#PLN-2021-00202
551 Congress Parkway – Preliminary PUD
Project Review for Planning and Zoning Commission

<u>Meeting Date:</u>	January 5, 2022
<u>Request:</u>	1. Comprehensive Land Use Plan Map Amendment from Office to High Density Residential 2. Rezoning from M Manufacturing to R-3B PUD Multi-Family Residential 3. Preliminary Planned Unit Development review for a new 93-unit apartment development
<u>Location:</u>	551 Congress Pkwy
<u>Acreage:</u>	Approximately 6.62 acres
<u>Zoning:</u>	M Manufacturing
<u>Surrounding Properties:</u>	North: M Manufacturing South: M Manufacturing & B-2 General Commercial East: M Manufacturing West: B-2 PUD General Commercial & O PUD Office
<u>Staff Contact:</u>	Katie Rivard (815.356.3612)

COURTYARD (REAR) ELEVATION 1/16"

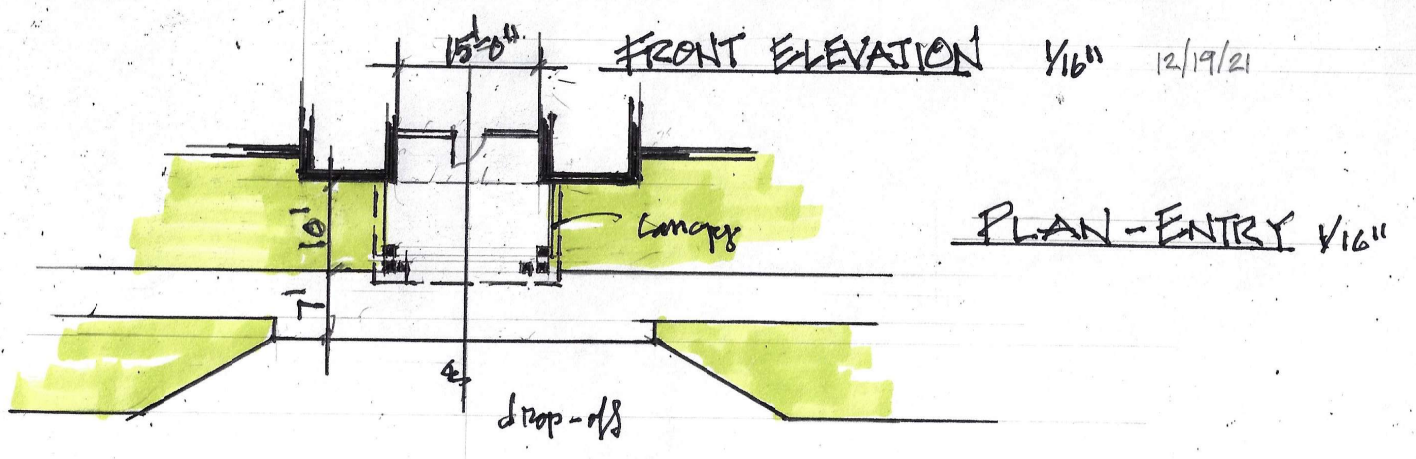
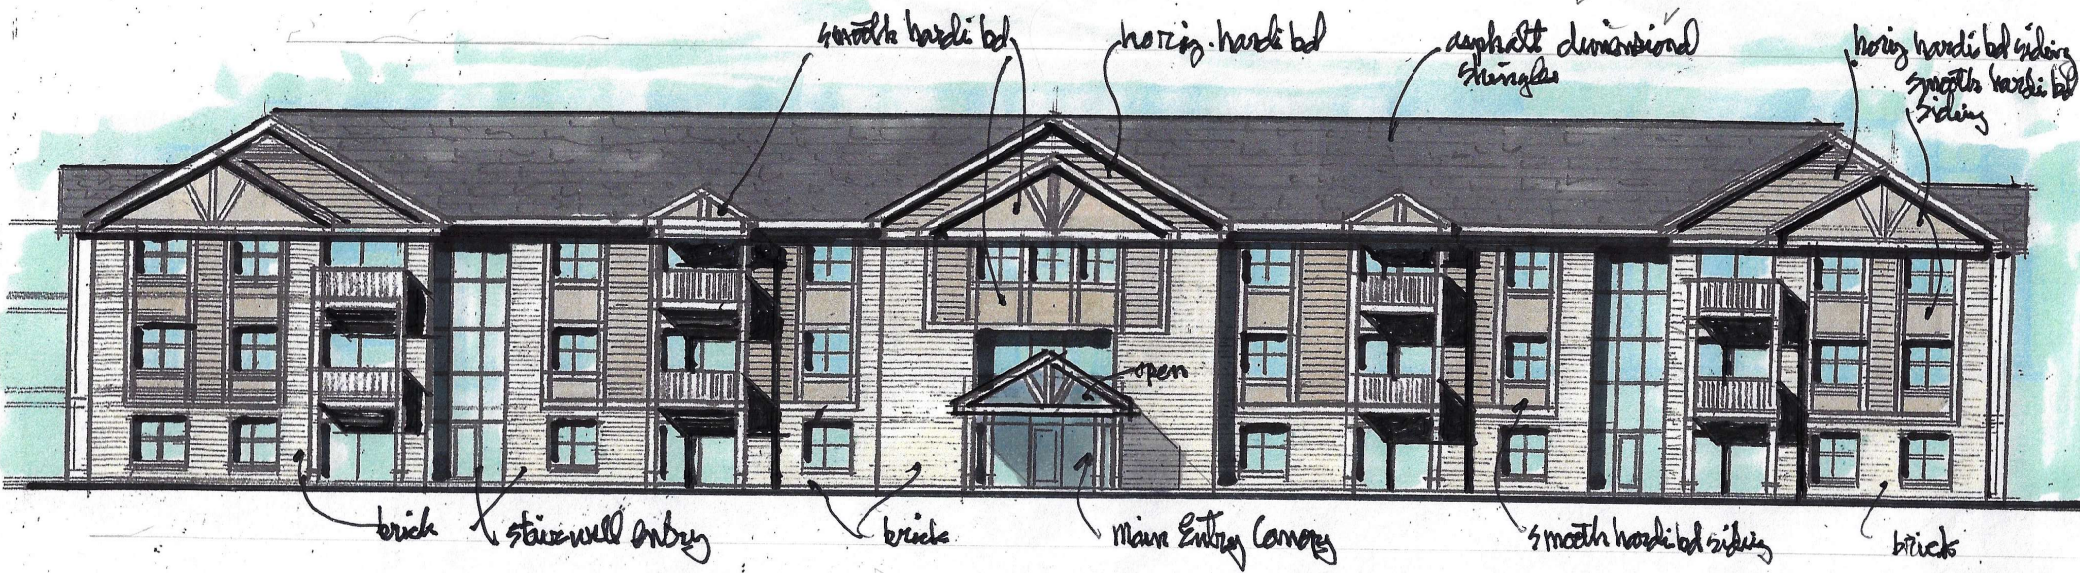
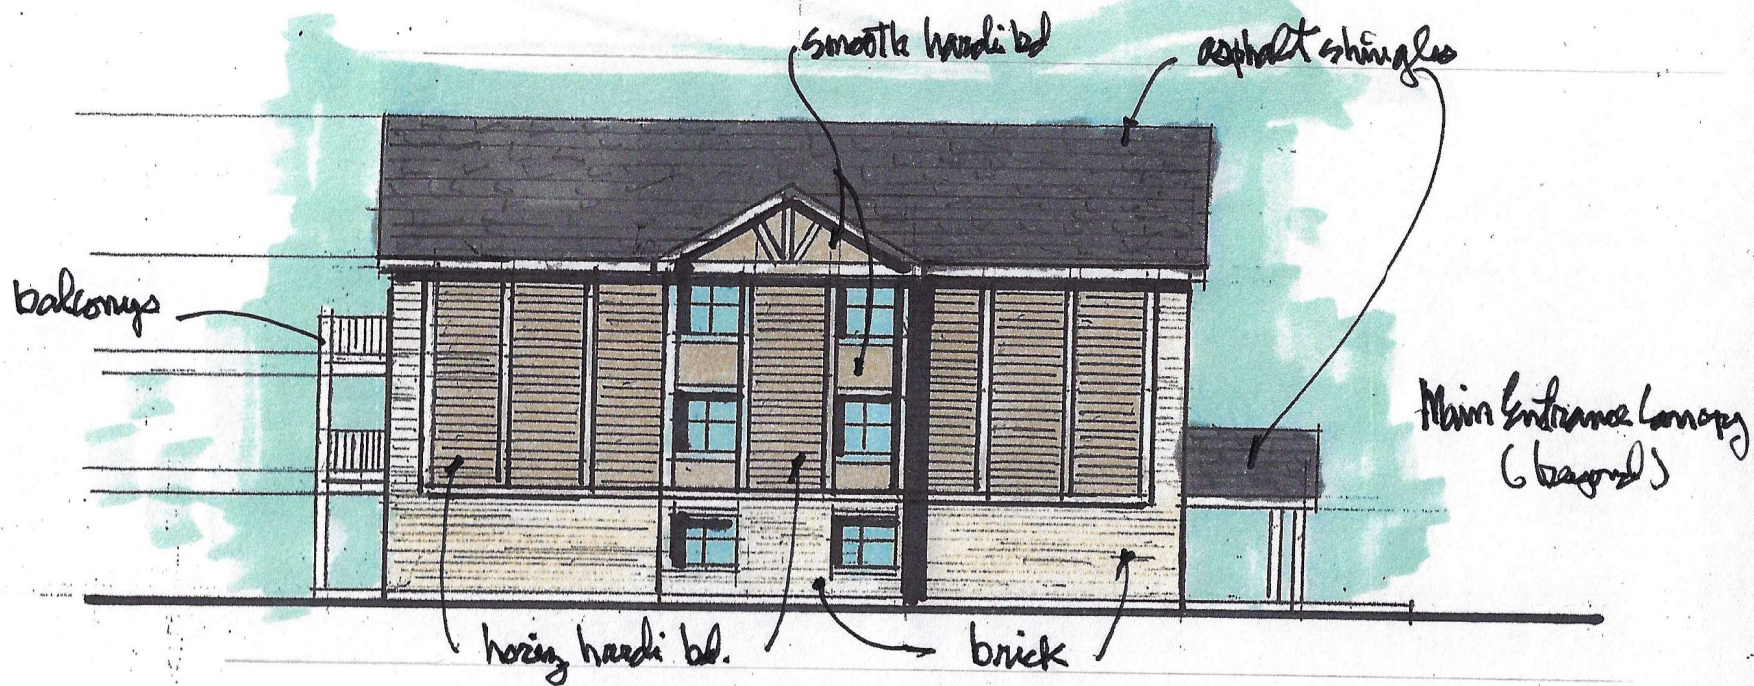
- In order for the proposed architecture to fit in with the character of the area, staff will continue to work with the Petitioner to enhance the side/end and rear elevations and incorporate of additional design elements such as brick bases on the balcony and covered entryway posts.

The petitioner must also include building colors and materials that are compatible with the surrounding area.

- A. Work with staff on ways to further enhance the side/end and rear elevations, including but not limited to, variation to the roof line and gable peaks.
- B. Work with staff on ways to incorporate additional design elements, including but not limited to, brick on the bases of the balcony posts and entryway posts.
- C. Work with staff to determine the final building and balcony colors and materials, which should include varying Hardi board colors.

**GEOMETRY, PAVING
STRIPING, & SIGNAGE PLAN**
PRELIMINARY ENGINEERING
551 CONGRESS PARKWAY
CRYSTAL LAKE, ILLINOIS

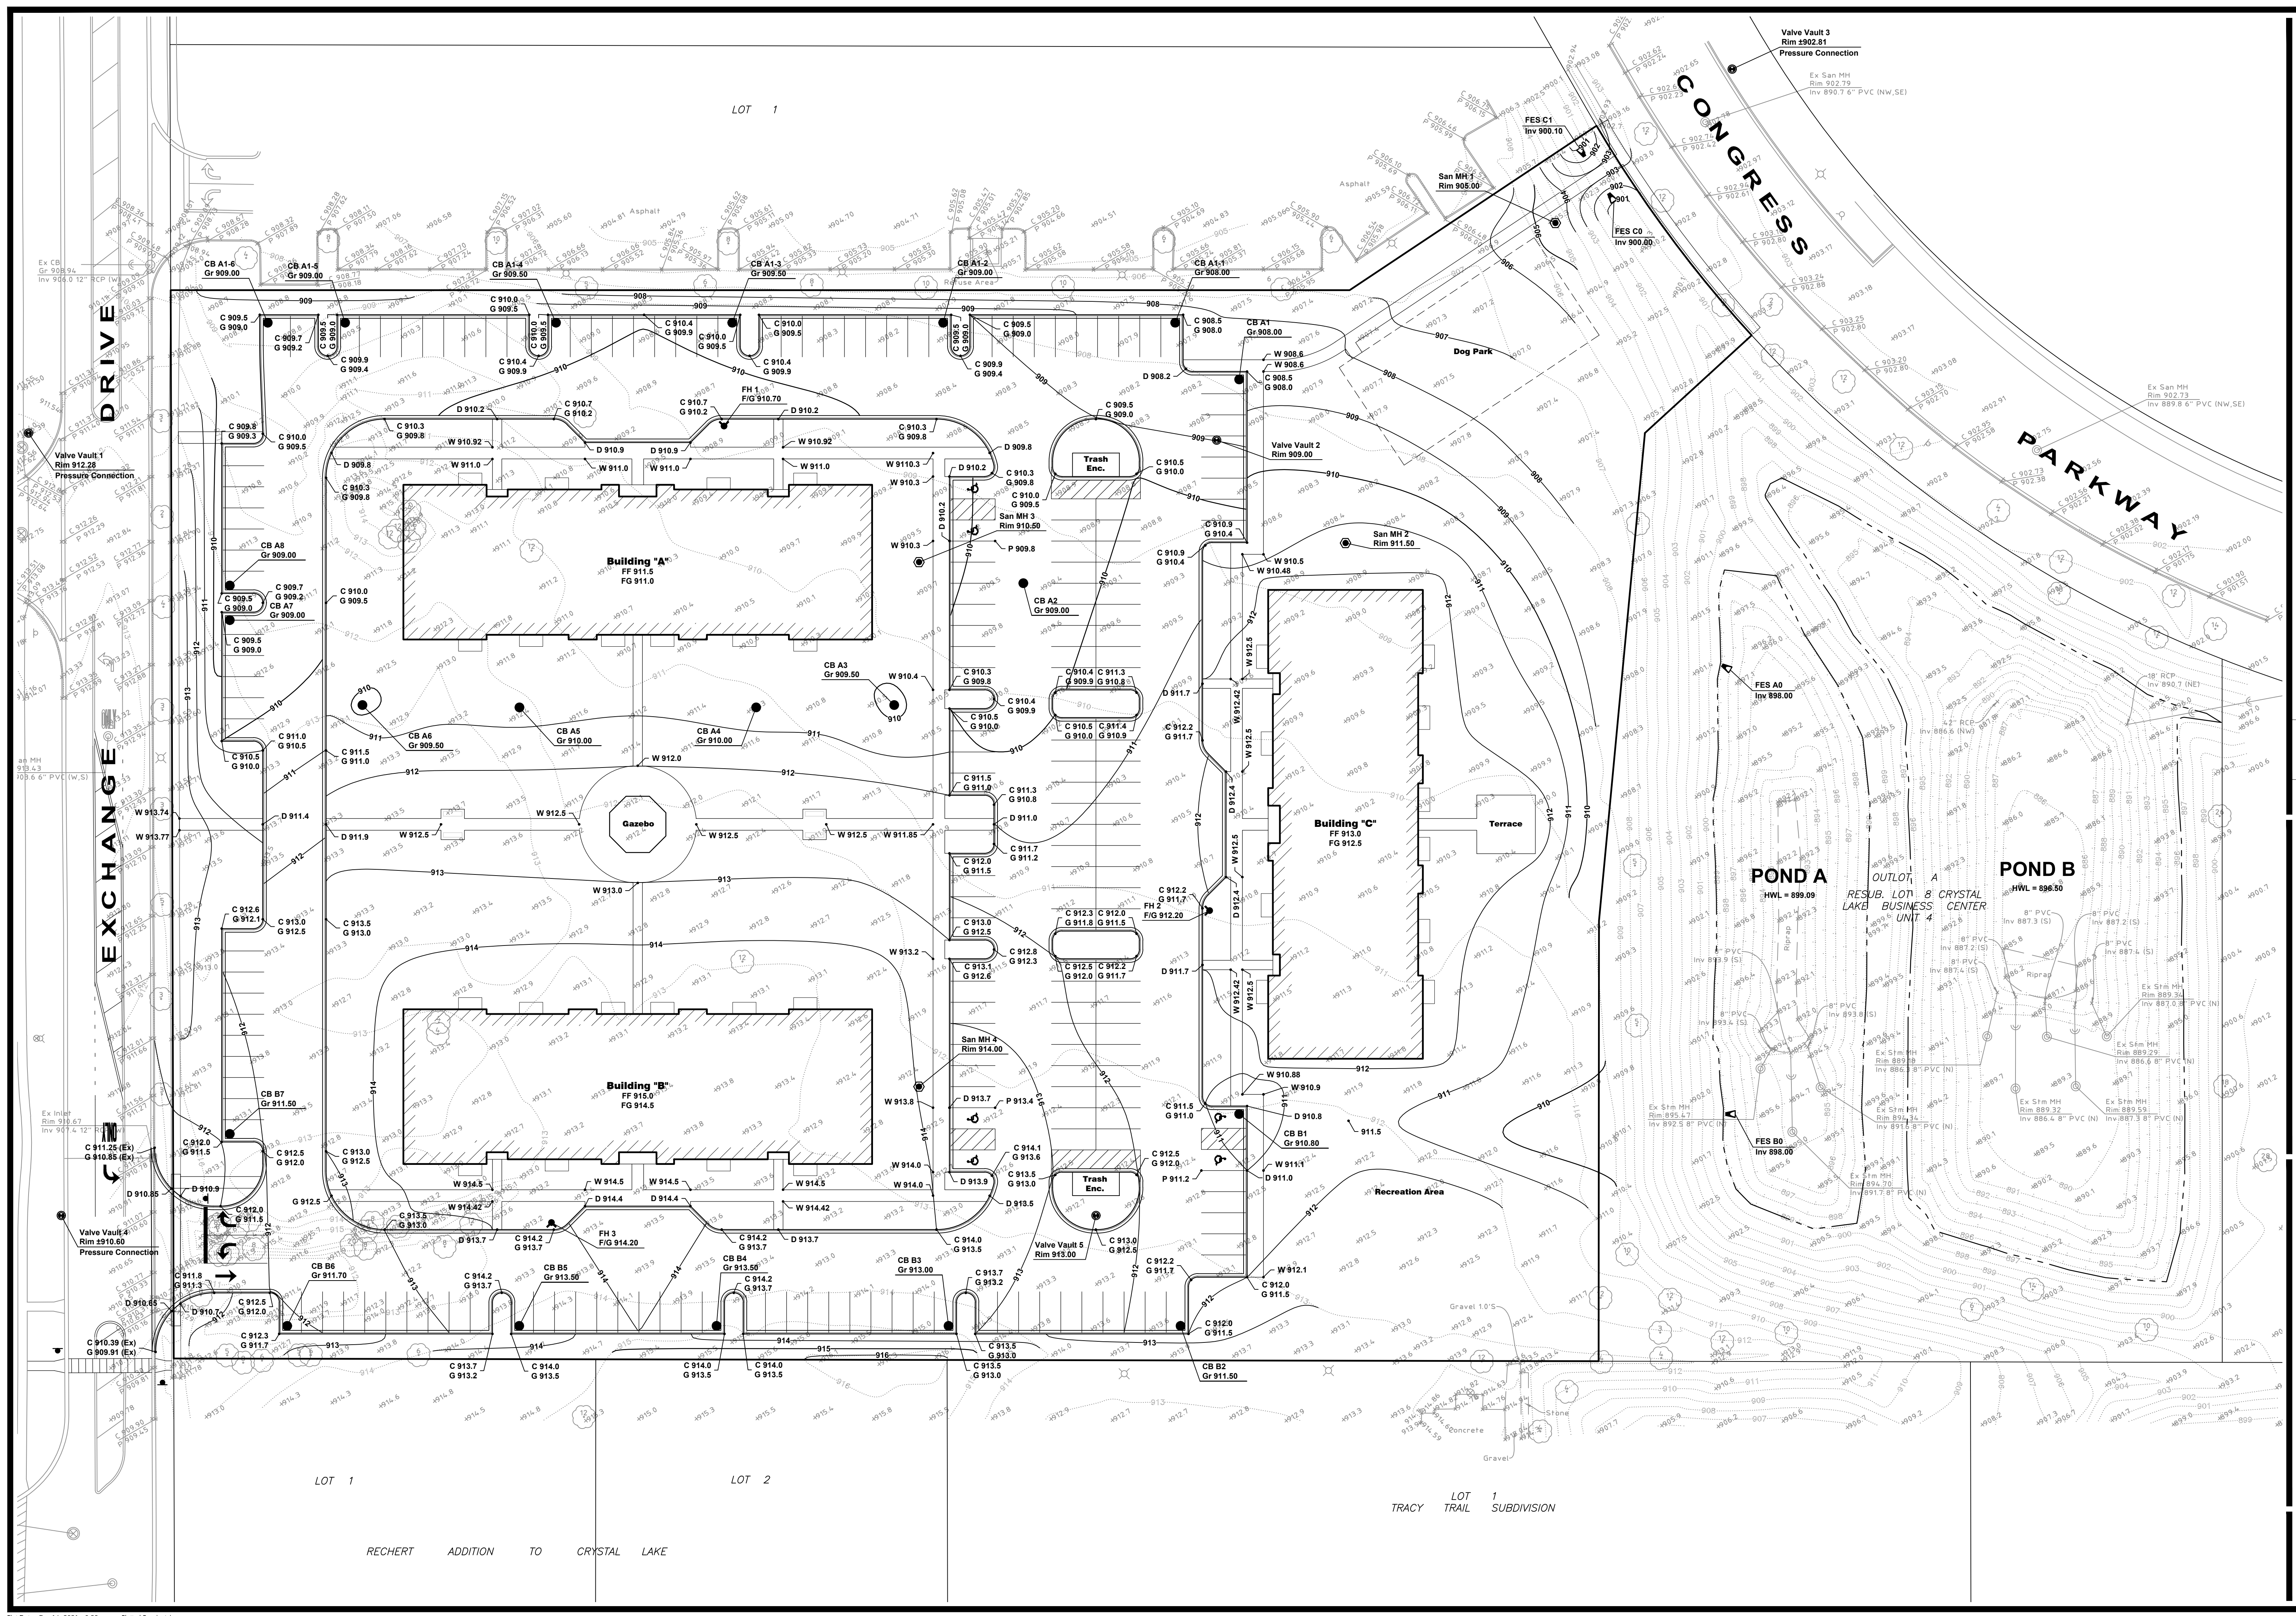
- The total width of the community drive aisles are 24 feet, which will require one lane to be marked with “NO PARKING – FIRE LANE” signs.
- Sidewalks and parkway trees are required along all roadway frontages. Sidewalk connections are provided between buildings and throughout the development. The sidewalks will connect to the existing sidewalk along Exchange Drive, as well as, the proposed sidewalk across the property’s frontage along Congress Parkway.

- J. Traffic Impact Study (Sam Schwartz Engineering, dated 12/06/2021, received 12/06/2021)
2. The internal drive aisles shall be posted with "NO PARKING – FIRE LANE" signs on one side of the road.
